# New Jersey Turnpike Authority

## Document Change Announcement

#### ***DCA2025DM-04***

**Section 8 Lighting and Power Distribution Systems, Subsection 8.3 Lighting Equipment and Materials**

Exhibit Error! No text of specified style in document.-1 Typical Roadway Lighting Standard Arrangements

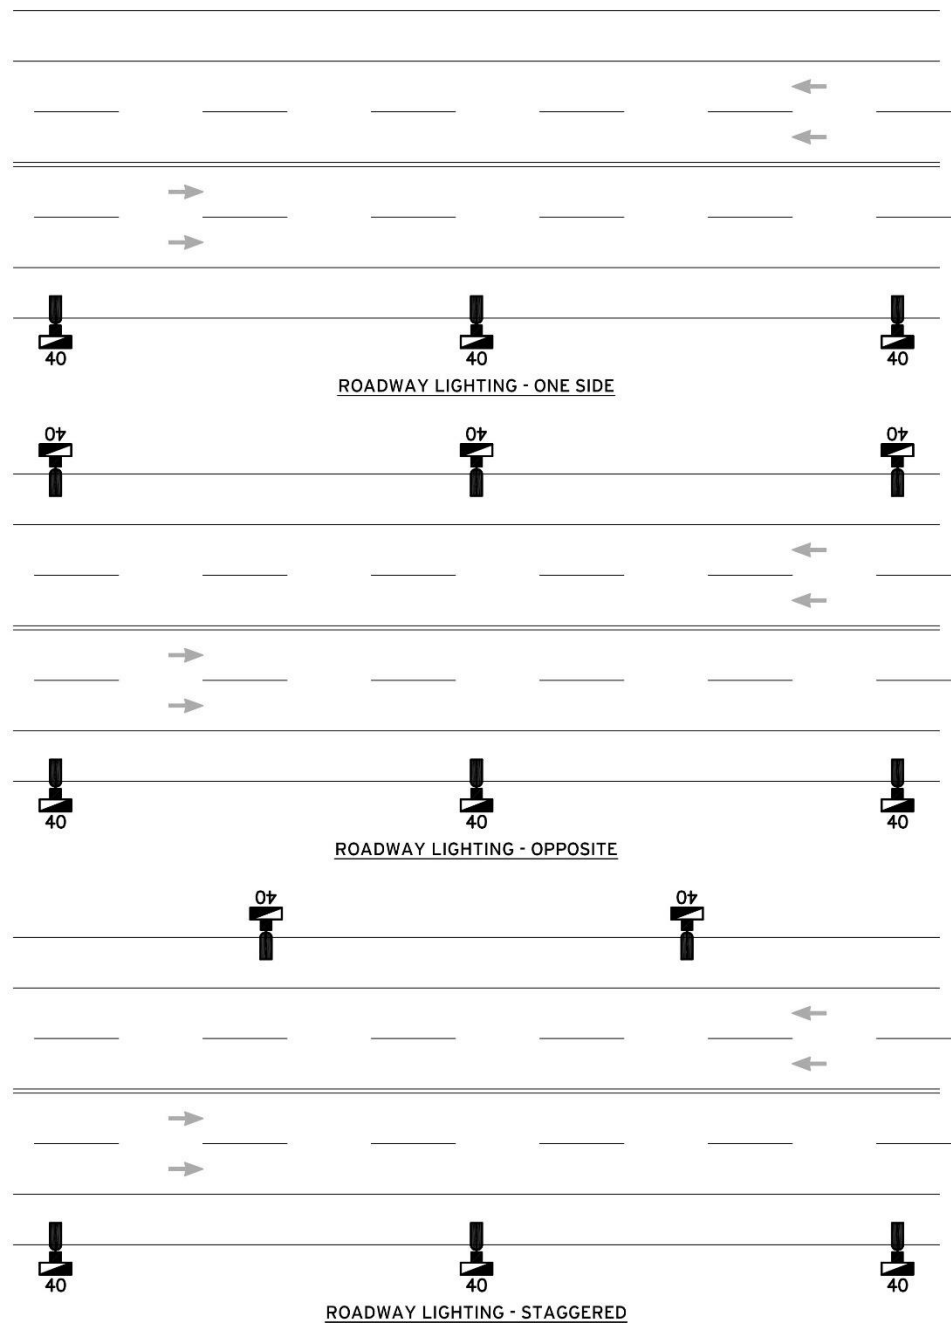
1. Lighting standards shall be arranged in one of the following three (3) methods; one-sided, opposite, staggered. Installation of Lighting Standard on a median barrier shall require prior approval by the Authority. An illustration of these arrangements follows in Exhibit 8-19. Selection of the method shall be based on the engineering analyses shown to produce the most effective and economical lighting system. The Engineer shall analyze both installation methods to determine the recommended scenario and shall describe the analysis as part of the submission report. Except where non-symmetrical geometry is encountered, lighting shall be evenly spaced and staggered to yield a pleasing visual appearance. See Subsection **Error! Reference source not found.** for more information regarding aesthetic treatment of lighting installations.
